Re: 2206 SW Red Barn Ln  
Lee's Summit, MO  
Hook Farms Lot 56  
Damaged Concrete @ Garage Door Inspection

Repair

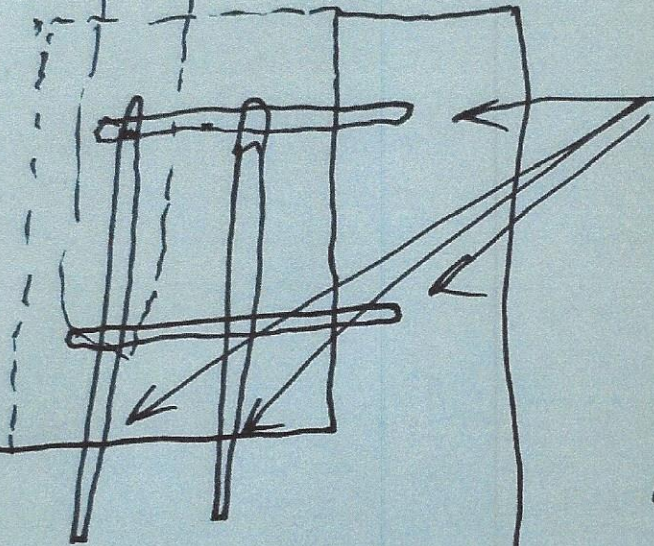
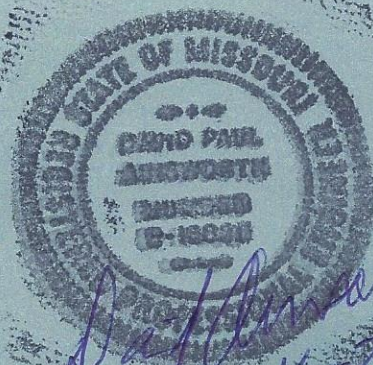
On October 3, 2023, I inspected the damaged concrete at the garage door opening at the above referenced property. When backfilling the garage area the equipment operator hit the lower right hand corner and broke a chunk of concrete off.

BROKE WALL

SAW CUT WALL

Drill & EPOXY

# 4 Rebar

2 - VERT

2 - HORZ

INSTALL NEW  
Wind Strap

To repair this damage you should saw cut the sections out and pin #4 rebar into existing form and pour back in accordance with the attached sketches. This repair will provide adequate support for the damaged corner.
